RE: DA-1250-58 Response to Comments

Atwell Project Number: 21003852

Please see below for Atwell's response to comments provided by Aurora Planning and Development Services on June 5, 2024. This is in regards to the proposed Flatrock Trail development, also known as DA-1250-58.

DR.	EAP	CH.	DJM
P.M.	DJM		
JOB	21003852		
SHEET NO.	03

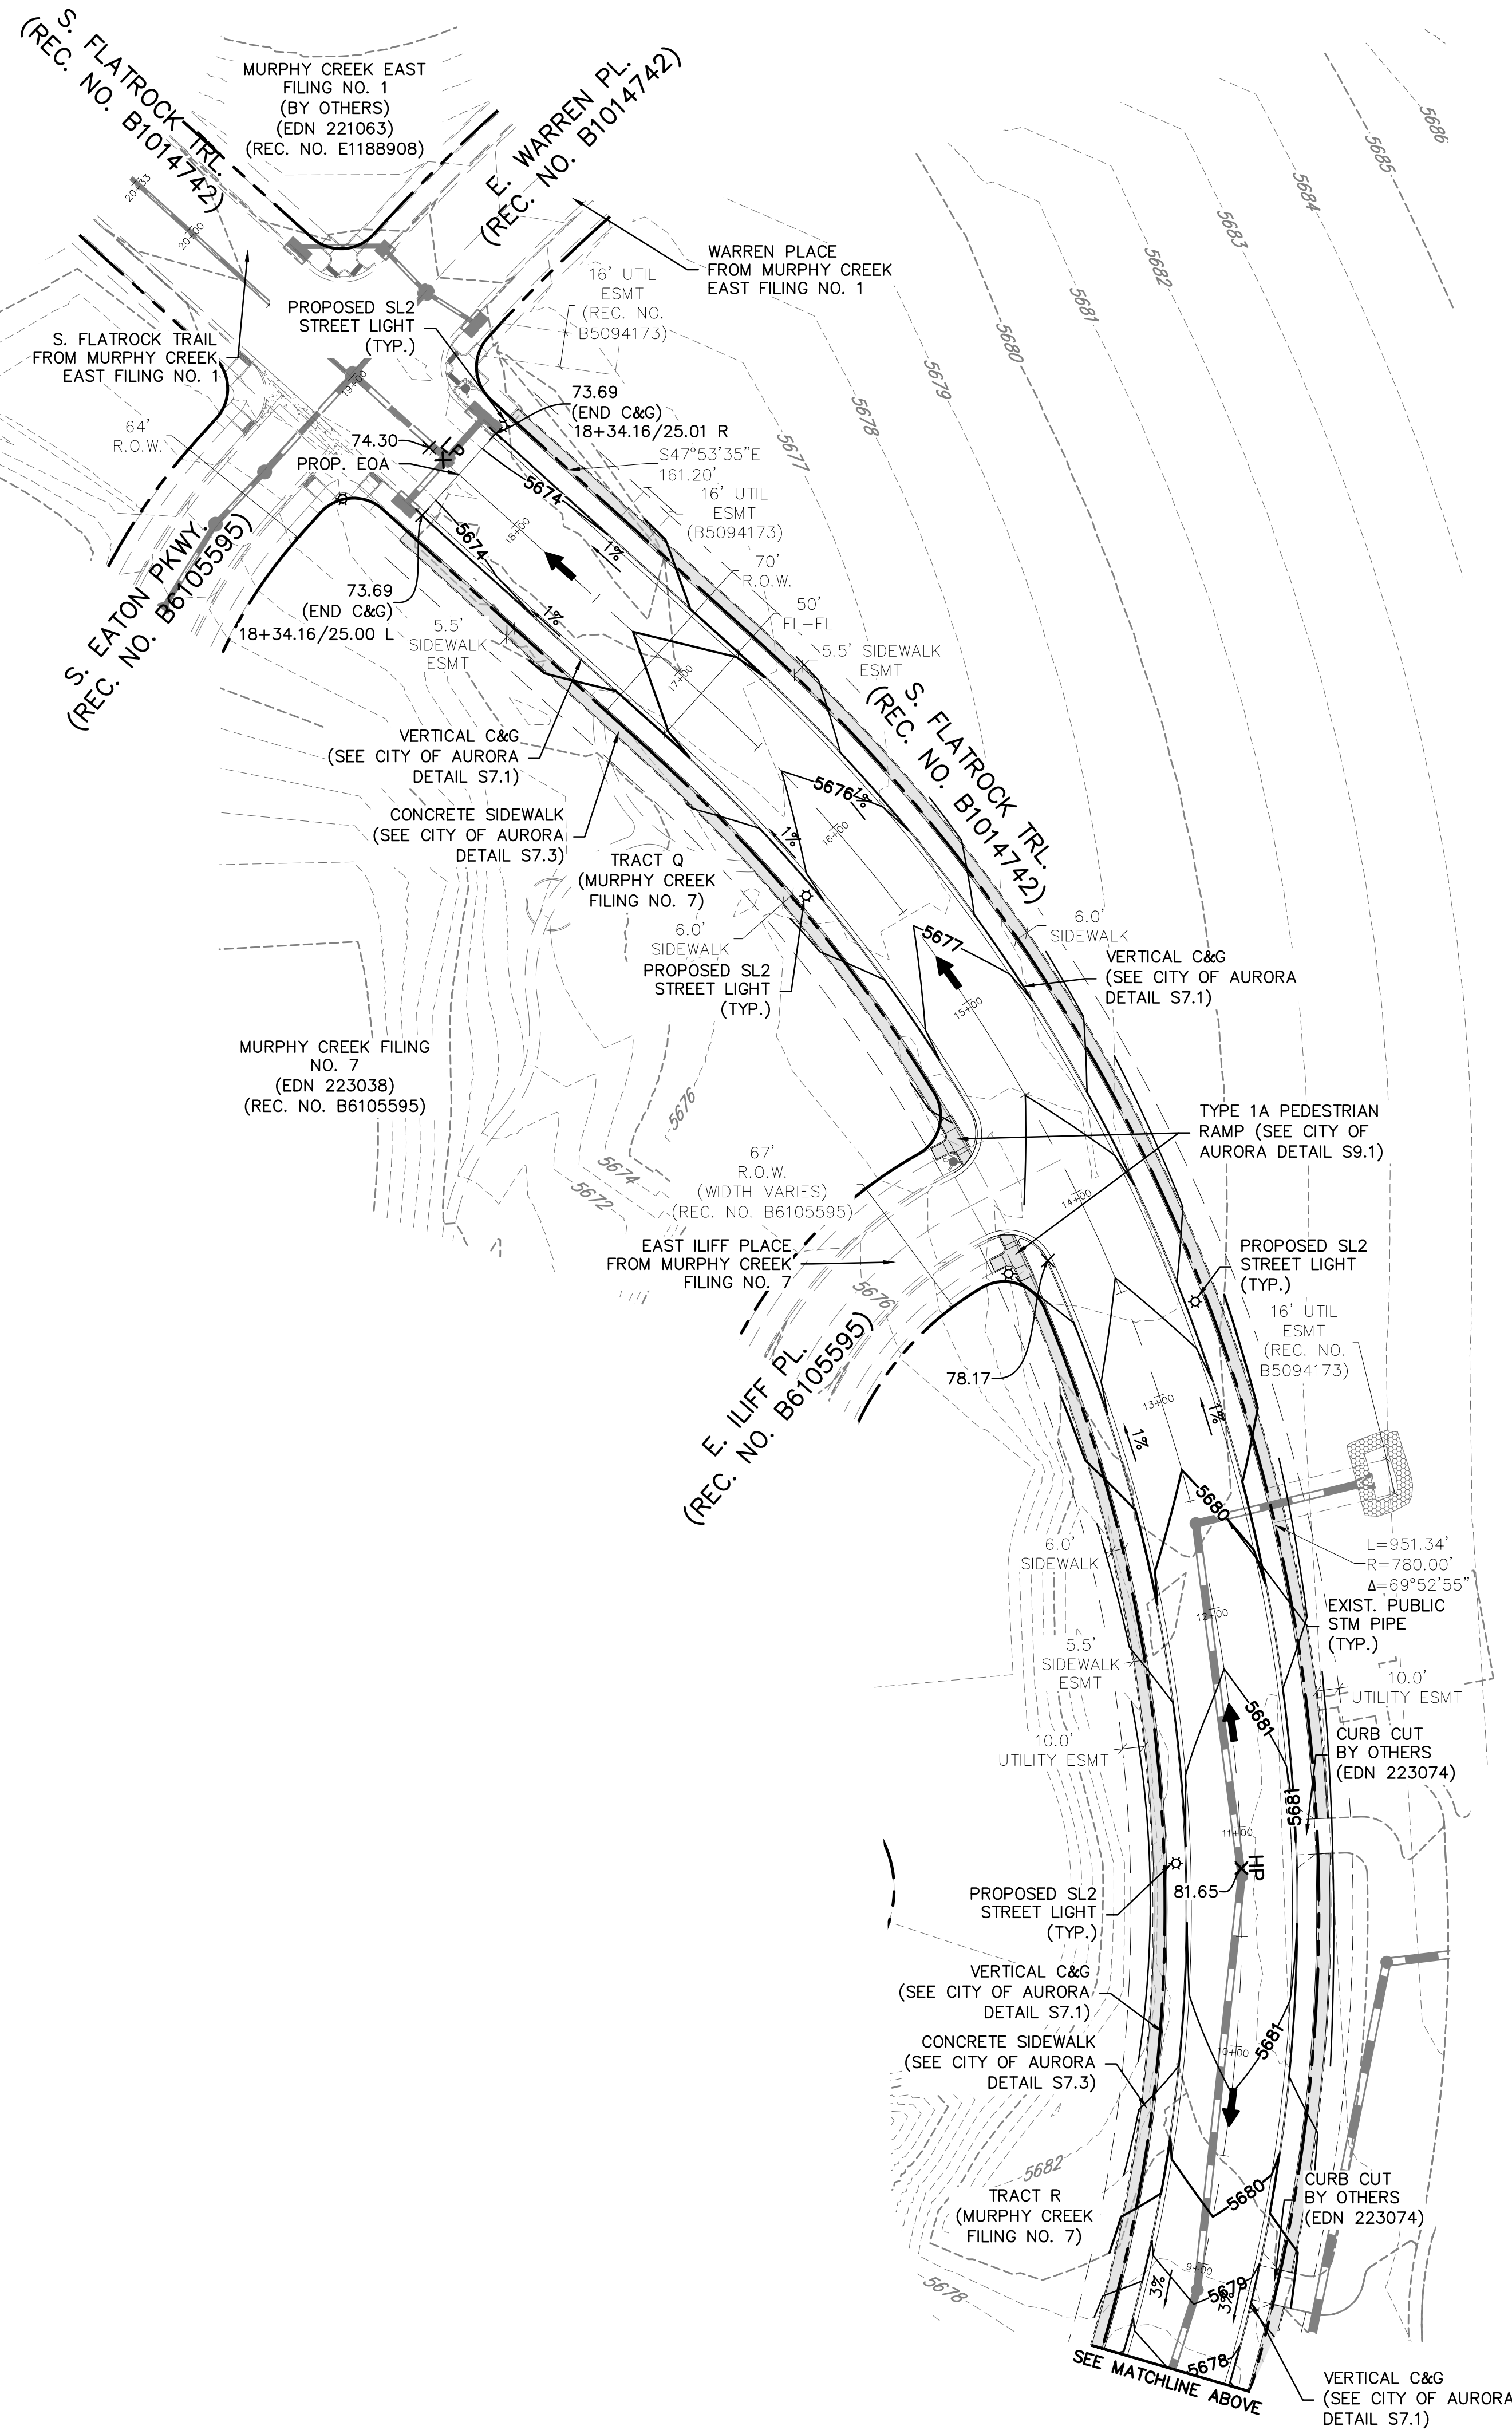
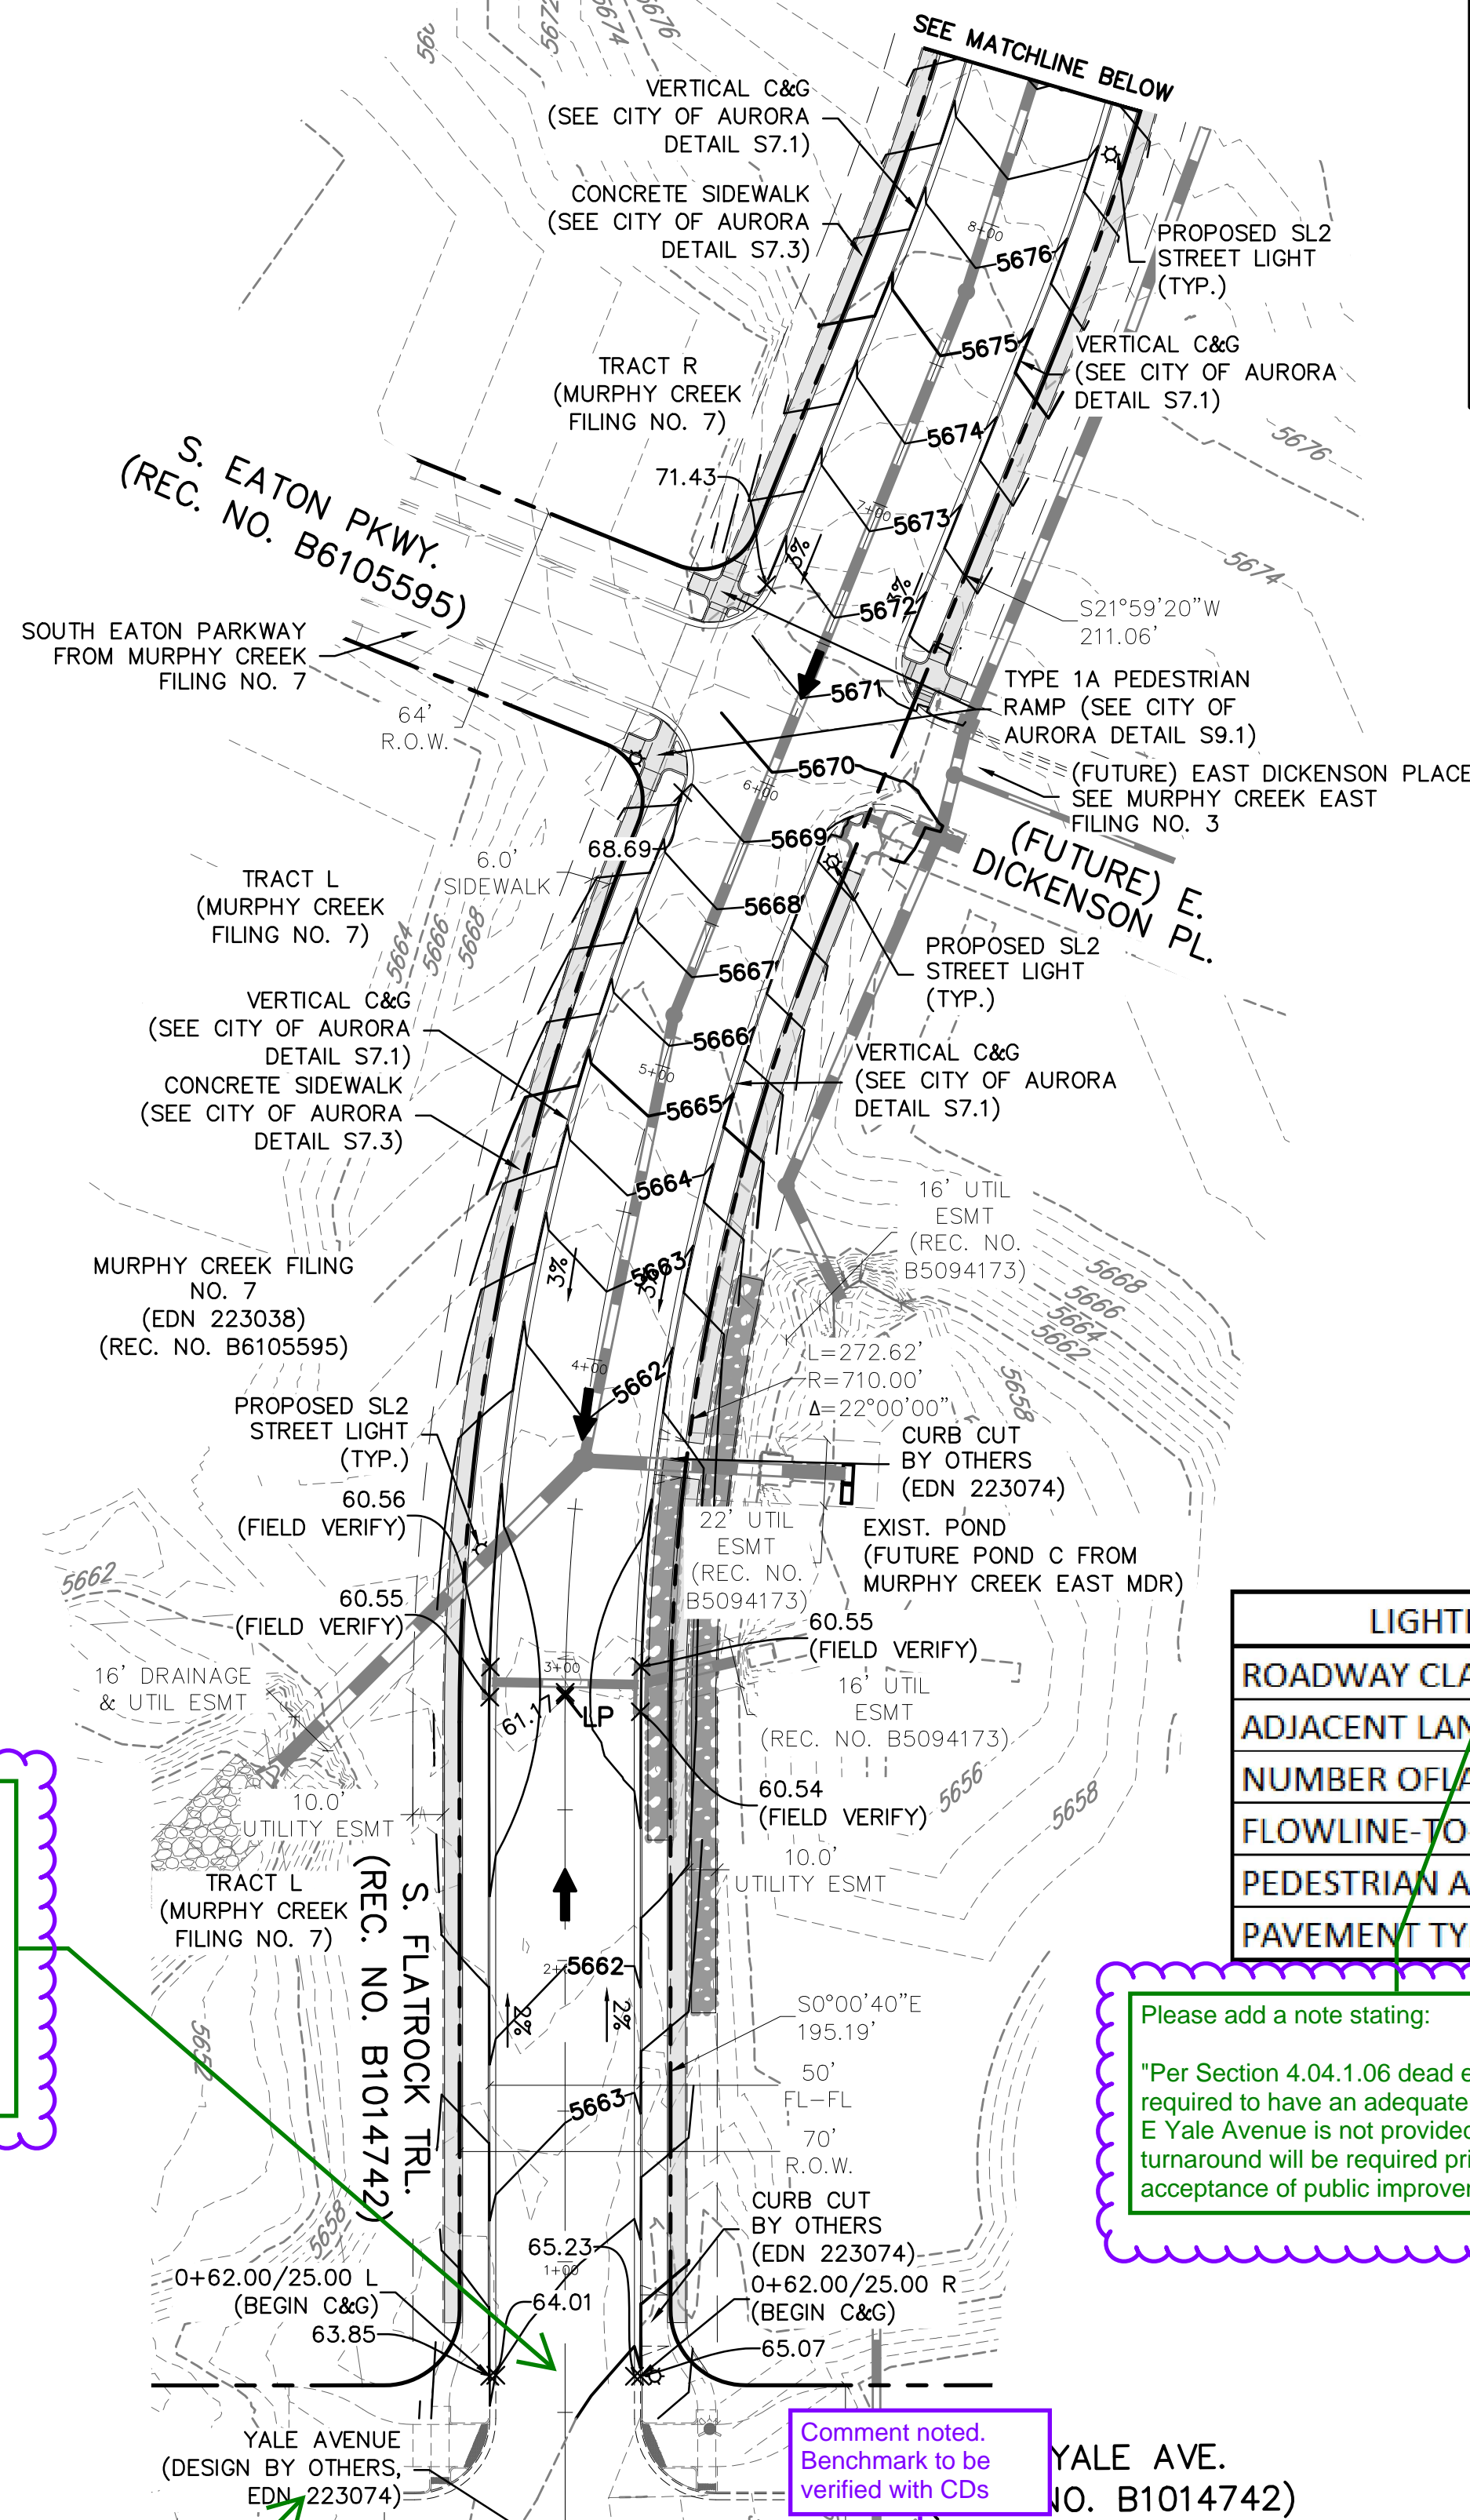
Show connection to proposed design.

Per Section 4.04.1.06 dead end streets are required to have an adequate turnaround. If E Yale Avenue is not provided, a compliant turnaround will be required prior to acceptance of public improvements.

EDN 223074 is the approved drainage plan. Instead please reference RSN 1742922 for the civil plans in review.

Please add a note stating:

"Per Section 4.04.1.06 dead end streets are required to have an adequate turnaround. If E Yale Avenue is not provided, a compliant turnaround will be required prior to acceptance of public improvements."

Advisory Comment, I couldn't find this benchmark number (4S6519SRE001) on the aurora website. During civil plan review, the benchmark and survey control drawings will be checked to ensure a correct benchmark is referenced, typ. ALL

The current design of Yale within the Murphy Creek East Fil. 3 is shown. Per discussion with Aurora, this is the correct design

RSN provided

note added

Comment noted. Benchmark to be verified with CDS
